Town of Hilton Head Island
Design Review Board Meeting
Tuesday, August 24, 2021 – 1:15 p.m.
AGENDA

i. Airport Terminal Renovation, DRB-001860-2021

Per feedback during our preliminary review held on 11/30/20, TWG has made the following modifications:

**SITE LAYOUT
PLAN**

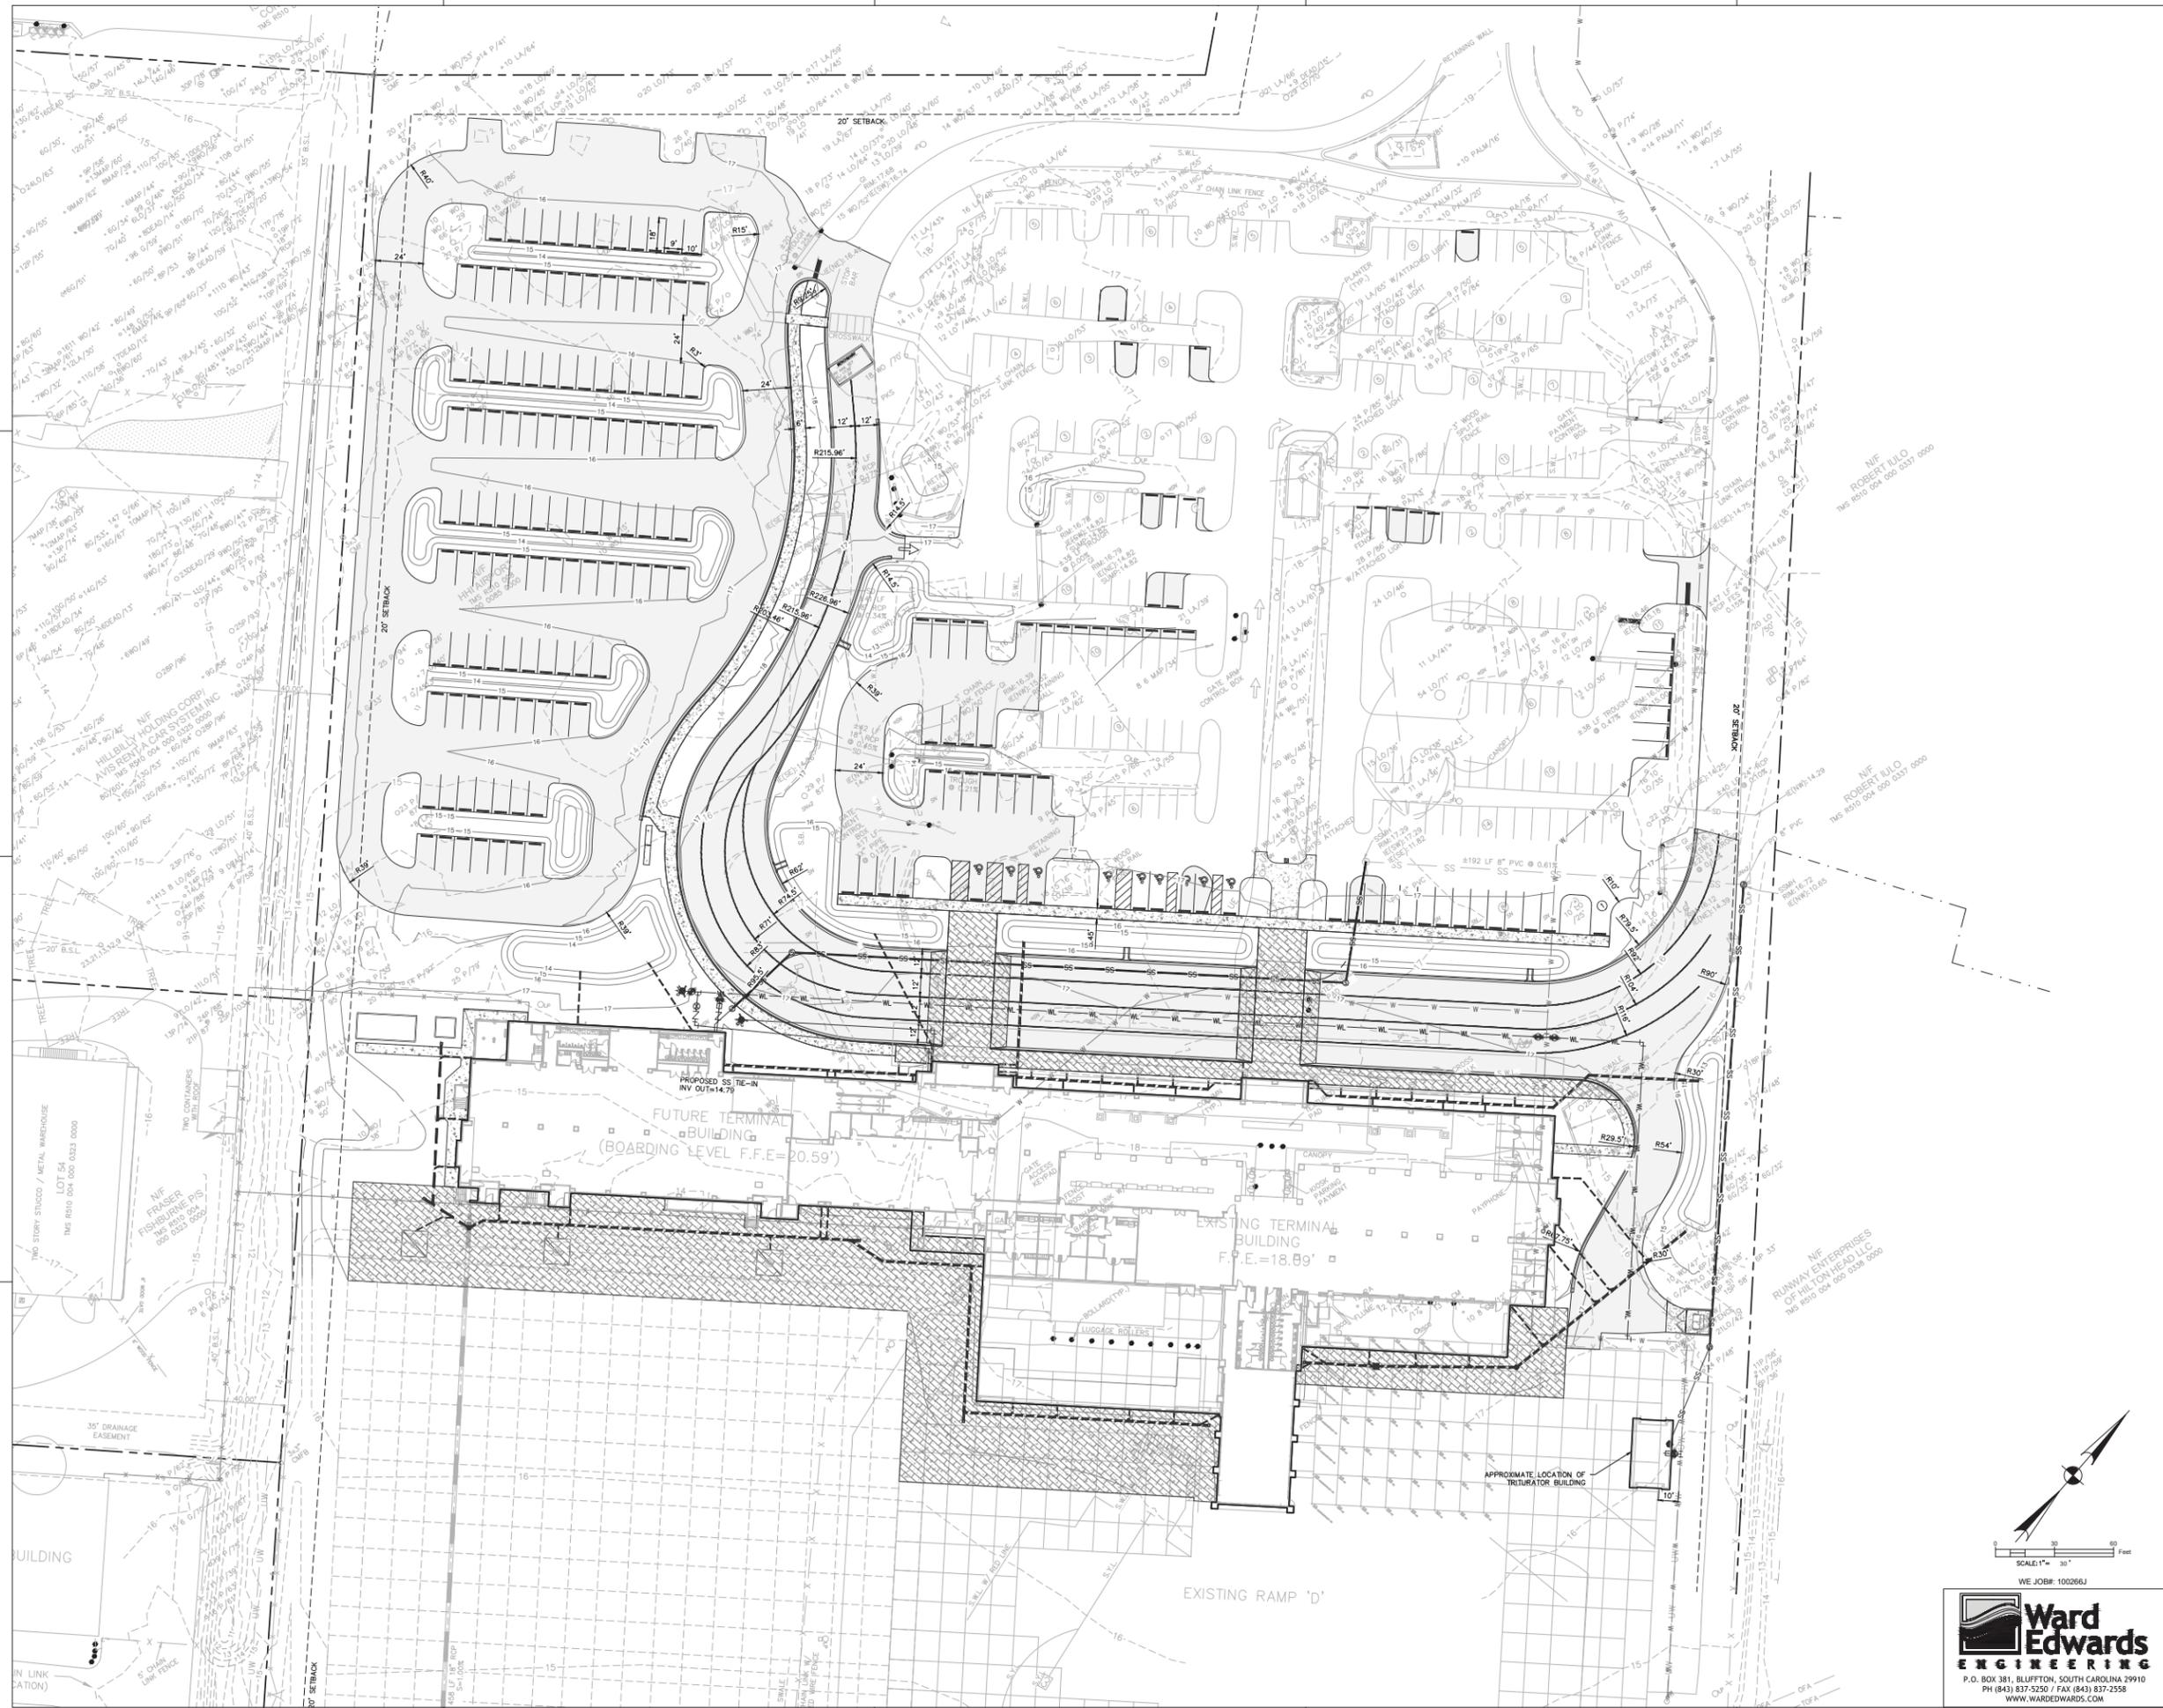
Comment: Why narrow the crosswalk on the parking lots side of the drop-off?

Response: The narrowing of the sidewalk has been removed. This is reflected on the civil site plans, landscape plans, and architectural site plans.

1 ENLARGED SITE PLAN
1/8" = 1'-0"

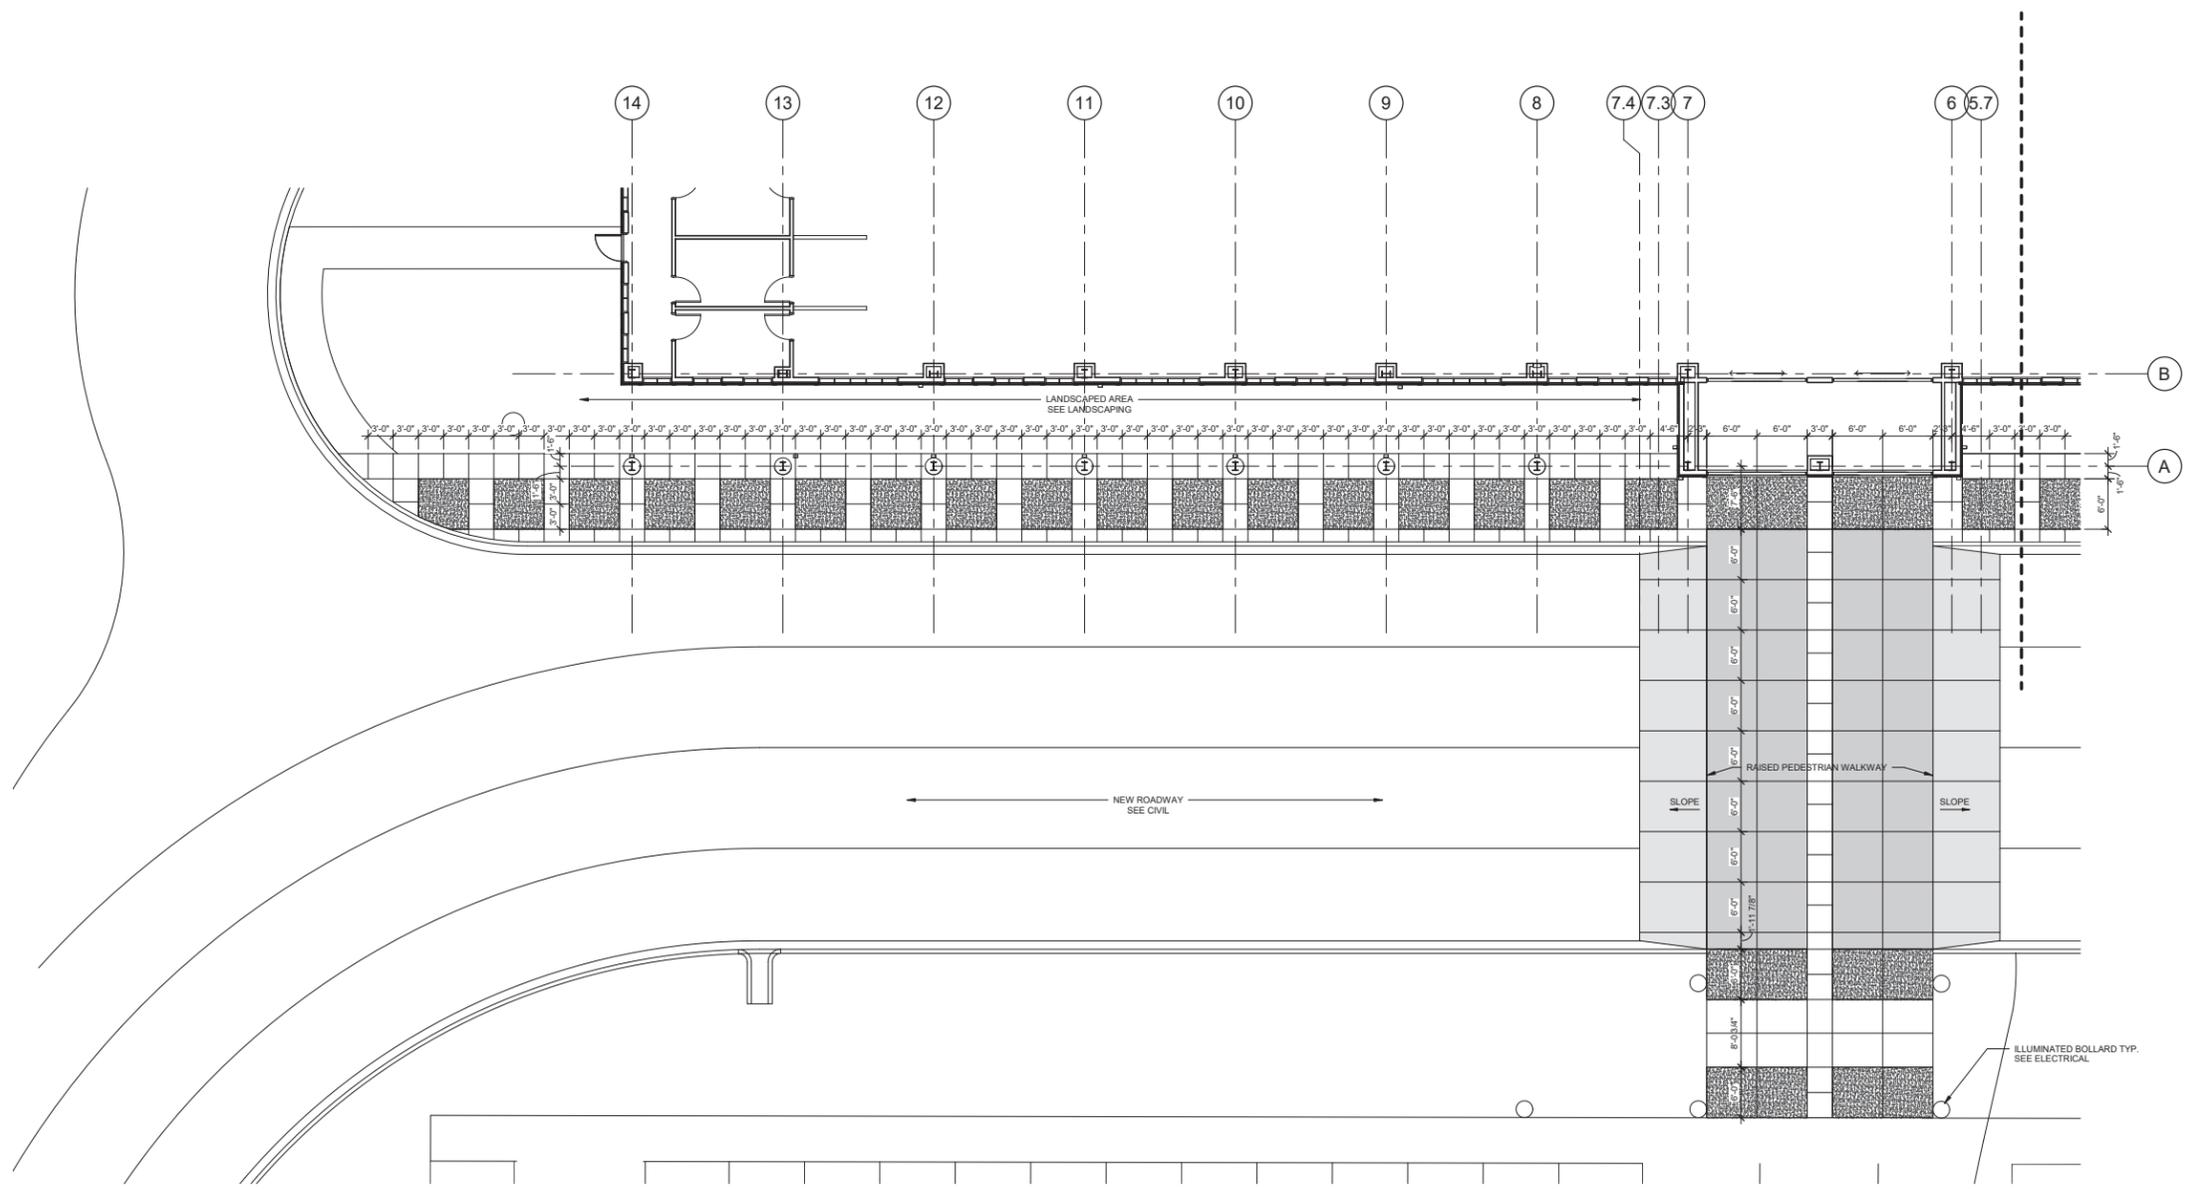
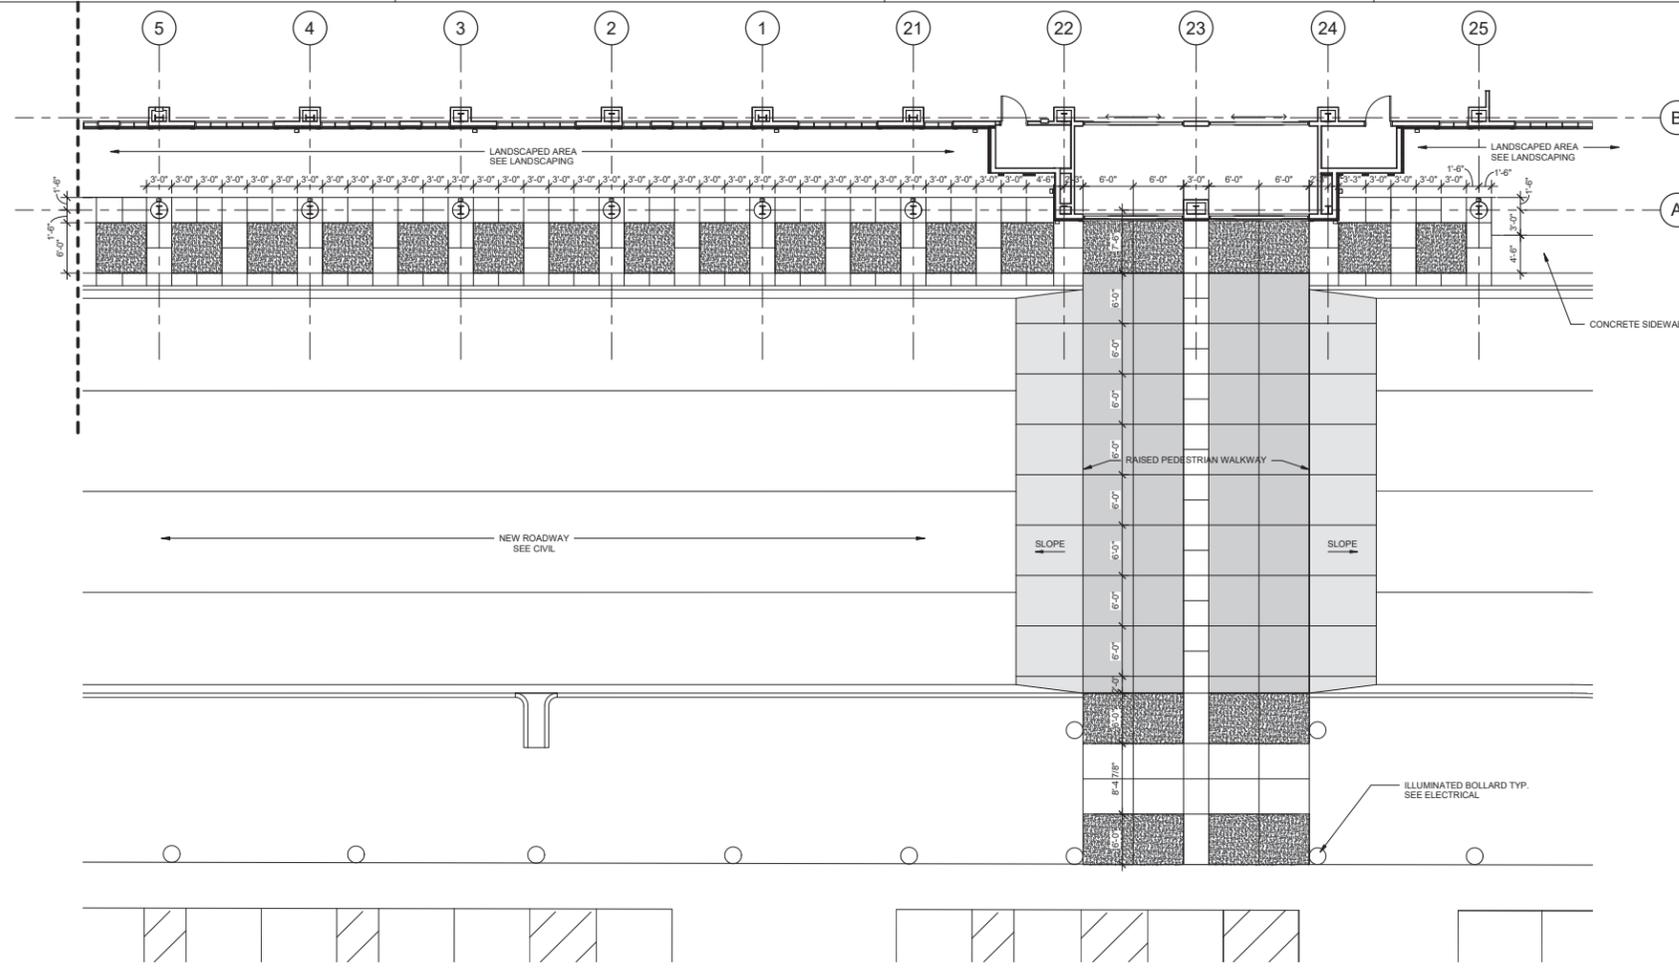
Comment: Articulate the ground plane at pavement markings & crosswalks.

Response: A combination of materials and colors has been incorporated into the passenger drop-off/pick up sidewalk and at the cross-walks to the parking lot. These include the use of oyster shell concrete finish. This is reflected on the architectural site plan and site details sheets.
